SB-10055104-8435

Roadster 2013 ST Upper Belt Guard Falling Off

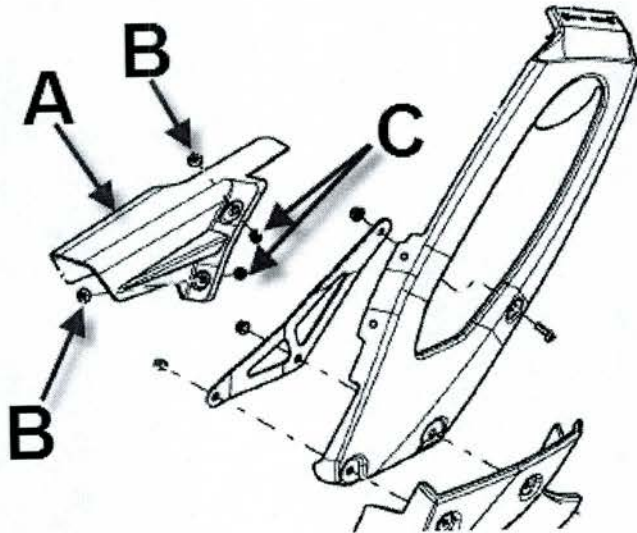
BRP has received reports concerning 2013 ST model upper belt guards falling off. This only affects 2013 models.

The problem has been identified as being the Torx screws being too short and not reaching the nylon of the nut. At the present time the MY13 parts catalog does not show the correct Torx screw, this will be corrected. Here is a breakdown of the parts needed:

- A. 705007213 upper belt guard
- B. 250000349 Torx Screw M6x10 --> 250000454 Torx Screw M6x12 (X2)
- C. 232361600 Nut M6 (X2)

If the belt guard has fallen off and needs to be replaced, order all parts above. If you want to be proactive and replace the screws, order the correct screws since the nut's nylon has not been touched.
